Work Order ID 73654

Item Name: Crosstube Fwd

DRAWING NO. D206-667-143	TITLE CROSSTUBE ASS'Y (206L HIGH FWD)	REV. C	DART AEROSPACE LTD ENGINEERING ORDER		D.E.O. NO. D206-667-143-C-1	SHEET NO. SHEET 1 OF 1	SCALE NTS
DRAWN <i>Q</i>	CHECKED <i>ASS</i>	MFG. APPR. <i>[Signature]</i>	APPROVED <i>[Signature]</i>		DE APPR. <i>[Signature]</i>		
DATE 11.07.15	DATE 11.07.20	DATE 11.07.21	DATE 11/07/21		DATE 11.07.21

A	NEW ISSUE	CP	11.07.15
REV.	DESCRIPTION	BY	DATE
DESIGN	qp	DART AEROSPACE LTD HAWKESBURY, ONTARIO, CANADA	
DRAWN	qp		
CHECKED	ASS	DRAWING NO.	REV. A
MFG. APPR.	N/A	DSI 9565	SHEET 1 OF 1
APPROVED		TITLE	SCALE
DE APPR.		SUPPORT INSTALLATION CHANGE	NTS
DATE	11.07.15	COPYRIGHT © 2011 BY DART AEROSPACE LTD THIS DOCUMENT IS PRIVATE AND CONFIDENTIAL AND IS SUPPLIED ON THE EXPRESS CONDITION THAT IT IS NOT TO BE USED FOR ANY PURPOSE OR COPIED OR COMMUNICATED TO ANY OTHER PERSON WITHOUT WRITTEN PERMISSION FROM DART AEROSPACE LTD.

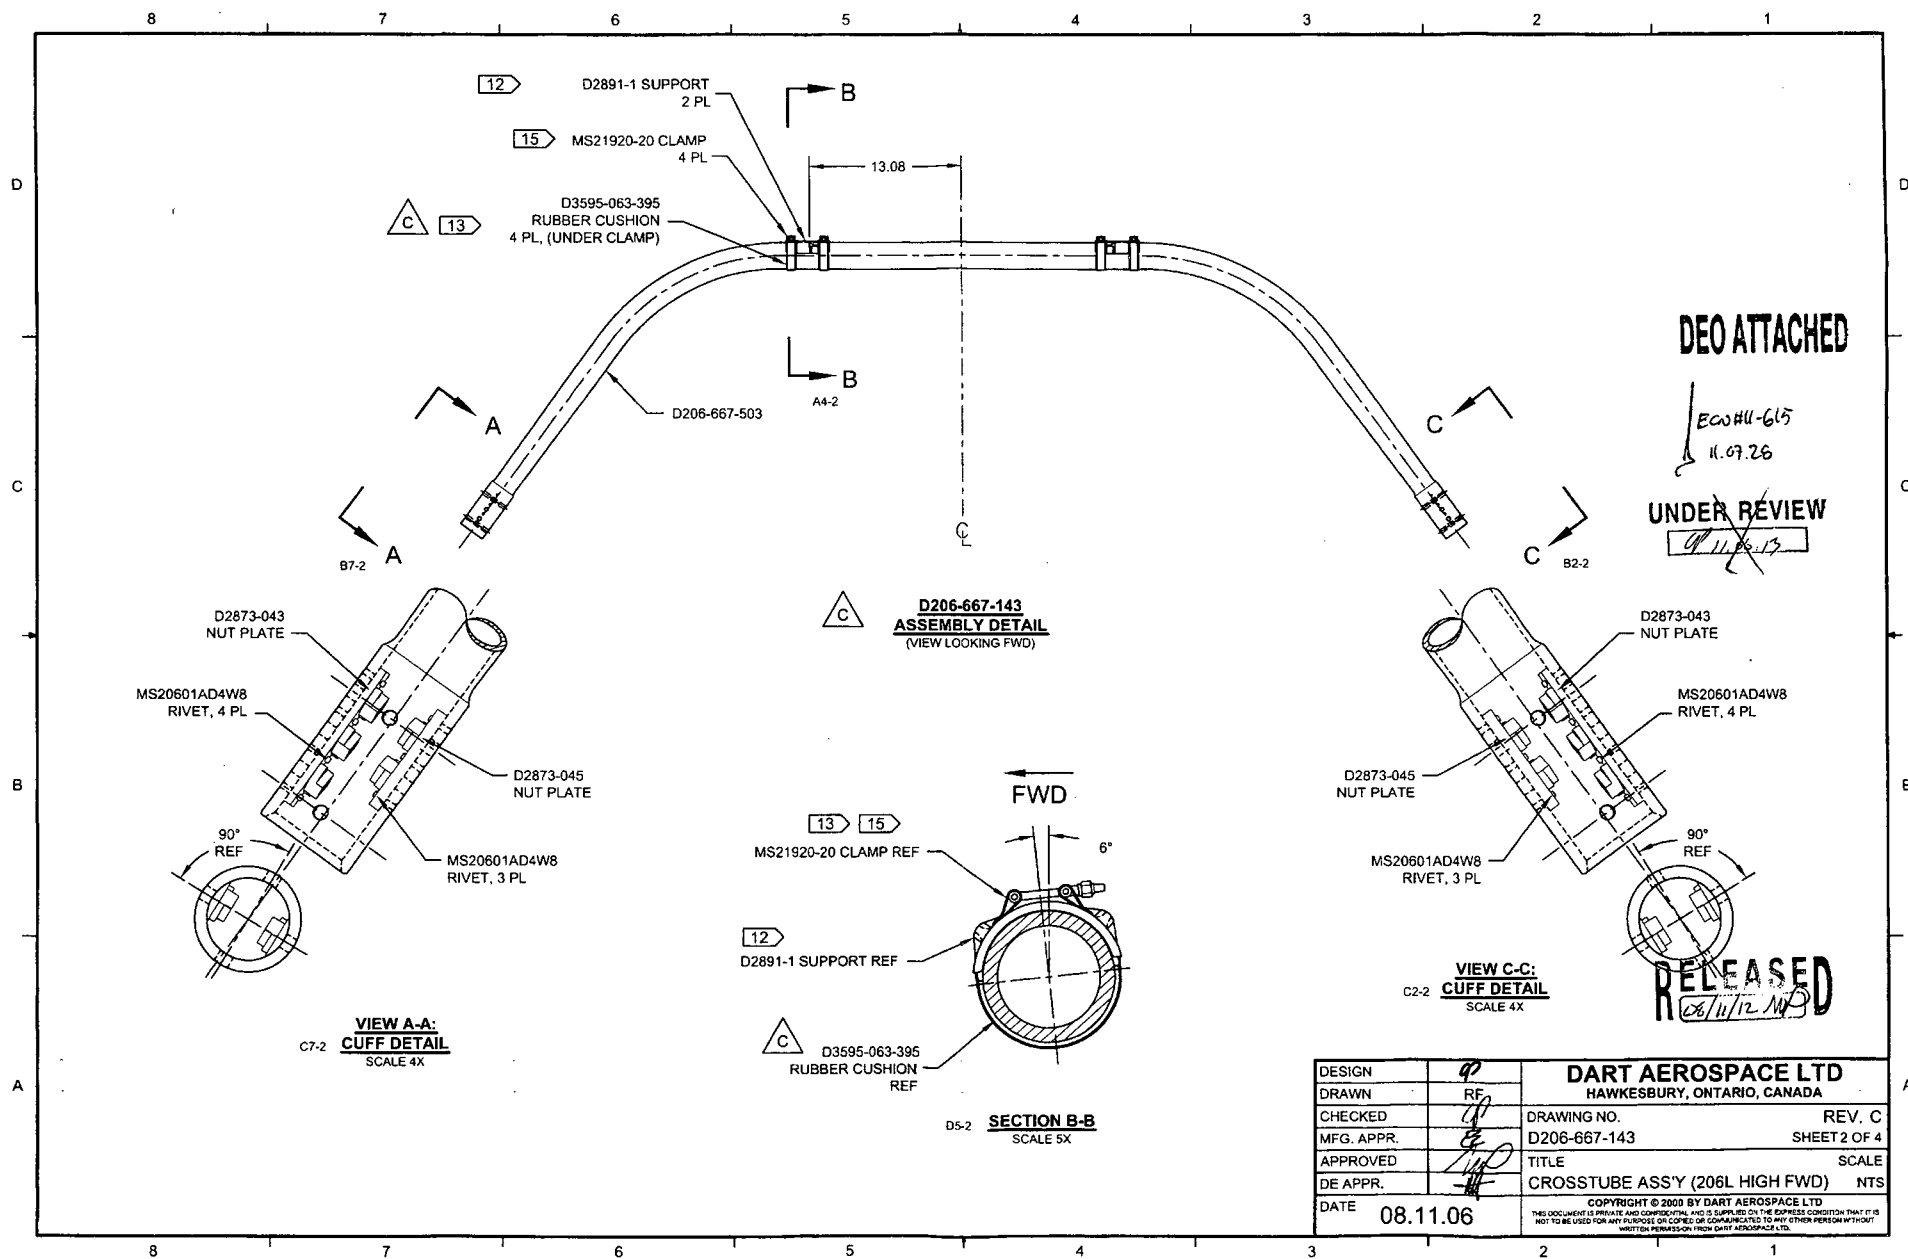
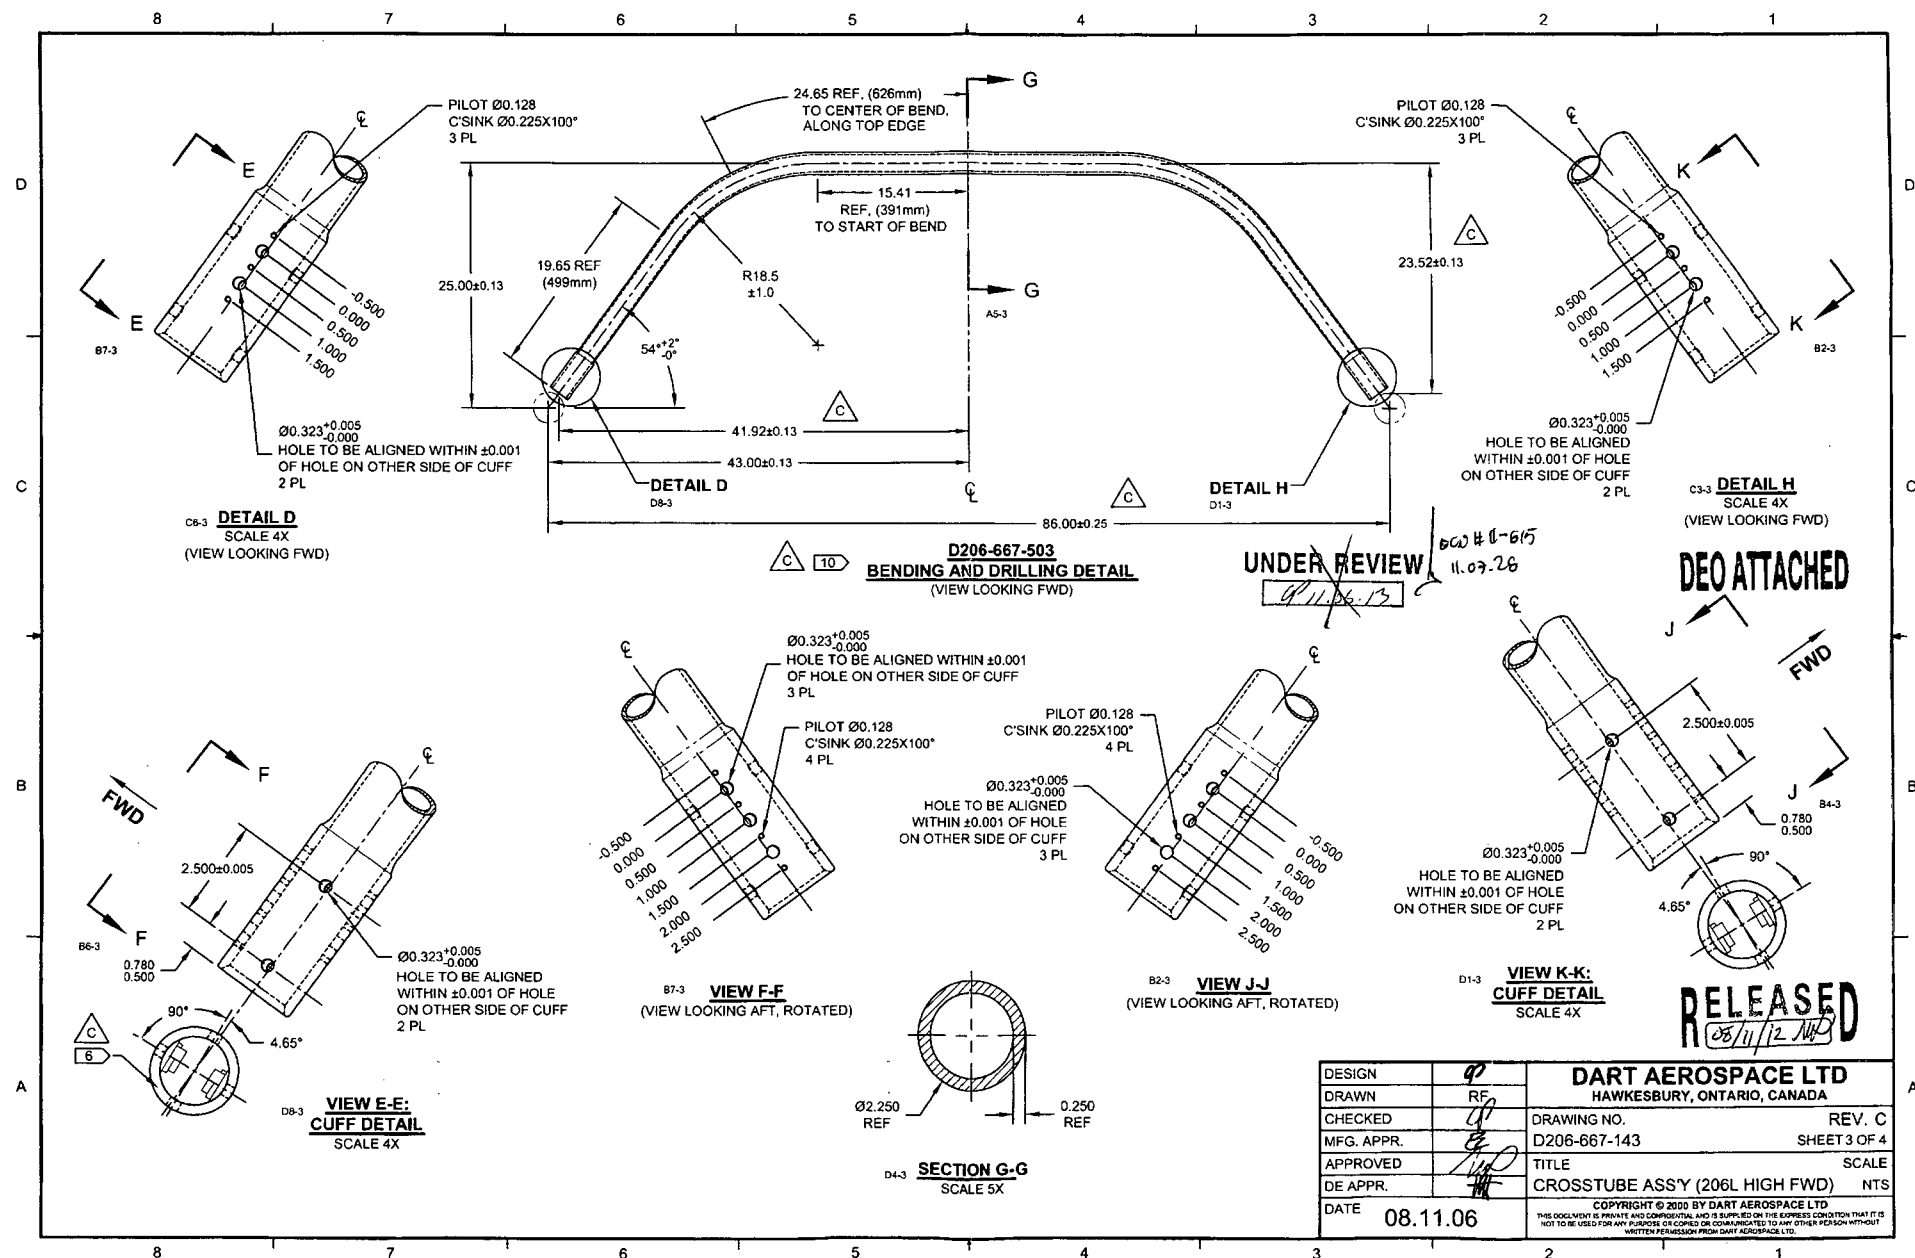
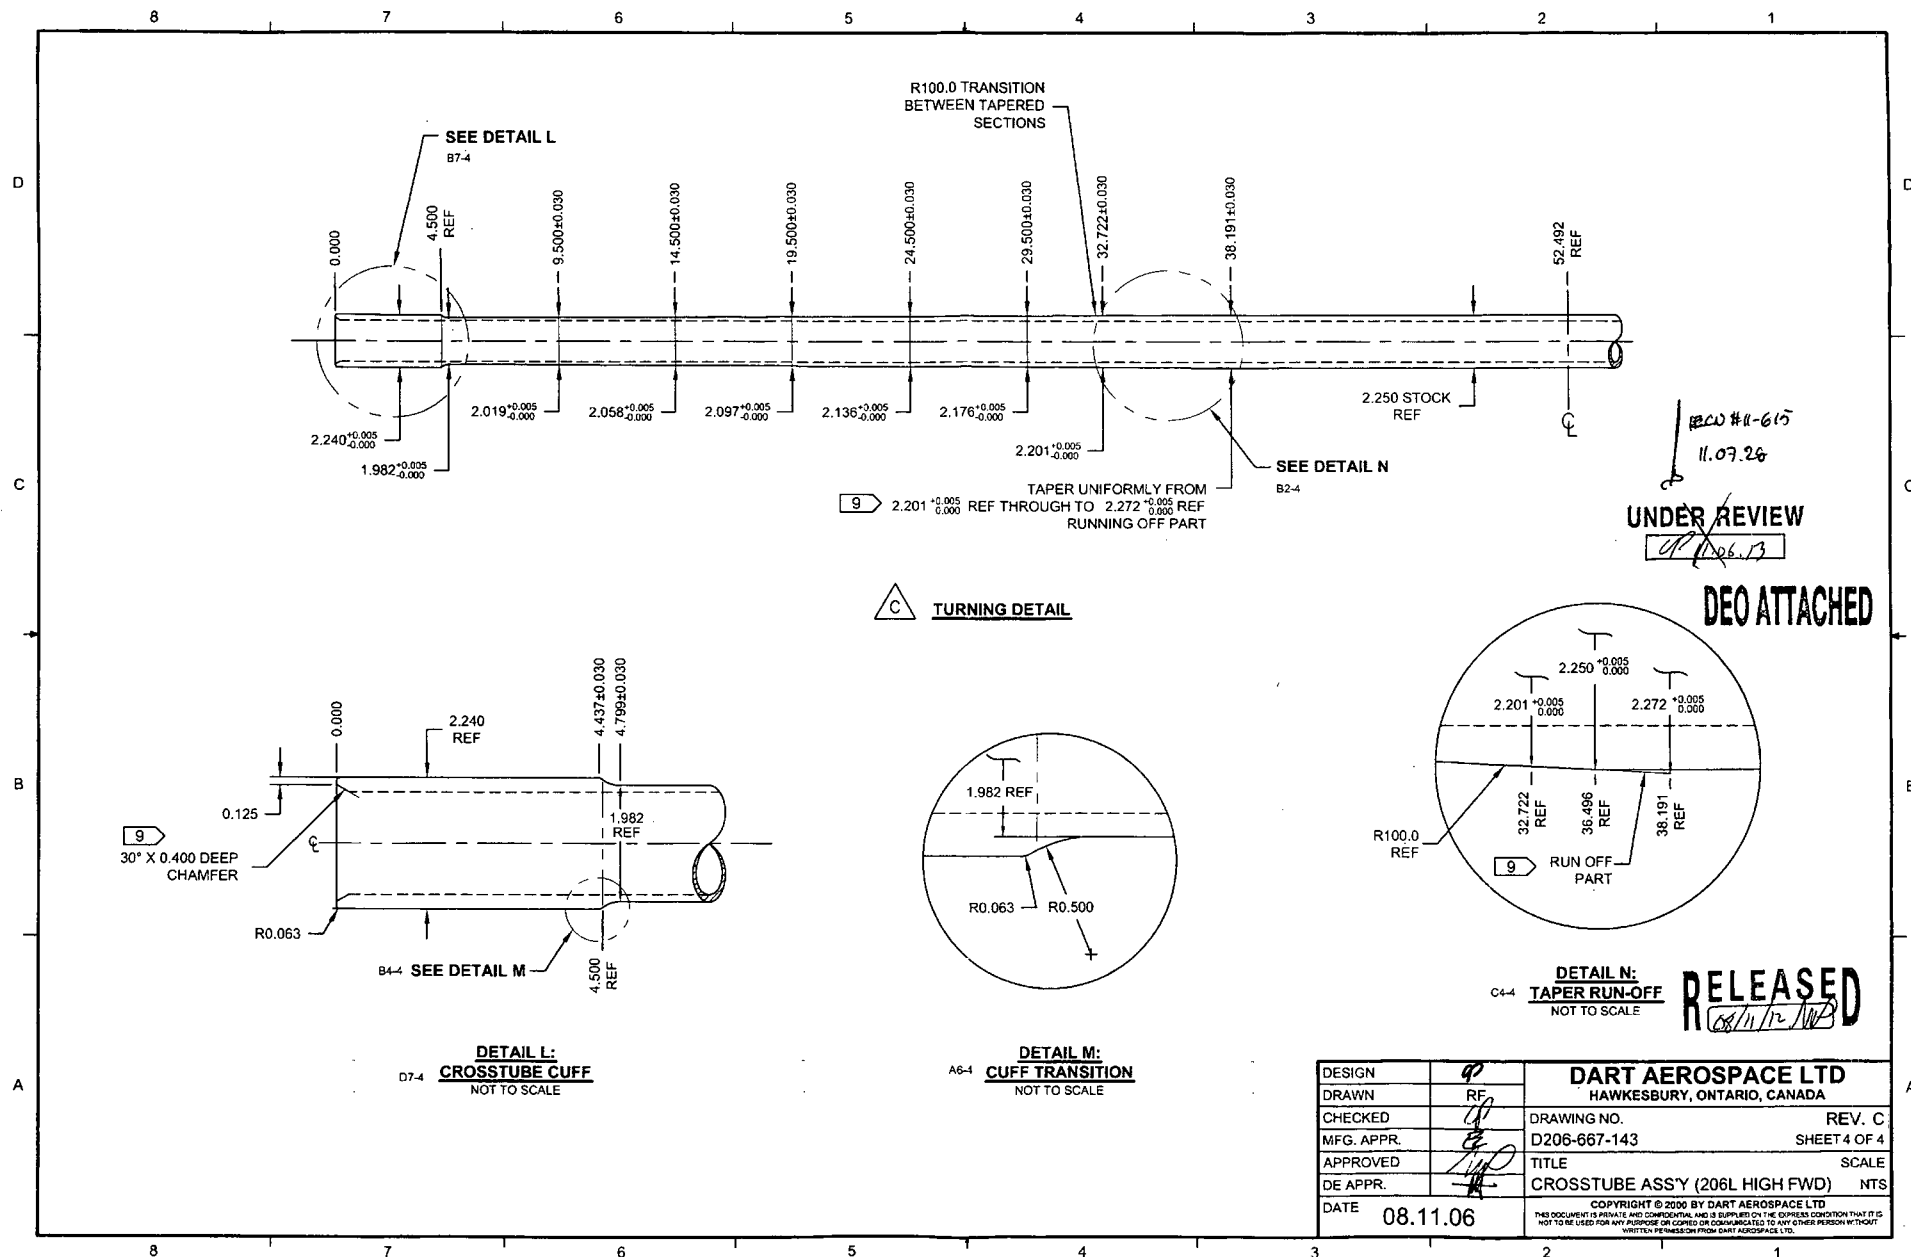
PURPOSE:

REPLACE MAGNOBOND WITH PROSEAL.

CHANGE:

IS:

Item	Qty -143	Part Number	Description
9	A/R	PROSEAL 890 B-2	SEALANT, AMS-S-8802 CLASS B-2

WAS:

9	A/R	MAGNOBOND 6398	ROCKWELL SPECIFICATION RBO-120-023 ADHESIVE (TEXTROM/BELL SPEC. 299-947-100, TYPE II, CLASS 2 ADHESIVE)
---	-----	----------------	---

NOTE 12 & 15, SHEET 1 IS AMENDED AS FOLLOWS:

IS:

WAS:

- 12) INSTALL D2891-1 SUPPORT USING 0.03" TO 0.06" THICK LAYER OF MAGNOBOND 6398 PER QSI 015. LET CURE FOR 12 HOURS AFTER INSTALLATION AND PRIOR TO PACKAGING.
- 15) TORQUE CLAMPS 80 TO 100 IN-LB. ENSURE AT LEAST 1.5 THREADS SHOWING IN SAFETY AND THAT NUT HAS NOT BOTTOMED-OUT AFTER TORQUING.

- 12) TO INSTALL D2891-1 SUPPORT: ABRABE MATING SURFACE OF SUPPORT AND CROSSTUBE WITH 180-GRIT SANDPAPER AND REMOVE RESIDUE WITH MEK (OR EQUIVALENT). APPLY A 0.04" TO 0.07" THICK LAYER OF PROSEAL 890 CLASS B-2 (OR AMS-S-8802 CLASS B-2) SEALANT TO MATING SURFACE OF SUPPORT.
- 15) TORQUE CLAMPS 80 TO 100 IN-LB. ENSURE AT LEAST 1.5 THREADS SHOWING IN SAFETY AND THAT NUT HAS NOT BOTTOMED-OUT AFTER TORQUING. **PRIOR TO PACKAGING, RE-CHECK TORQUE ON CLAMPS AFTER PROSEAL 890 SEALANT HAS CURED FOR 72 HOURS.**
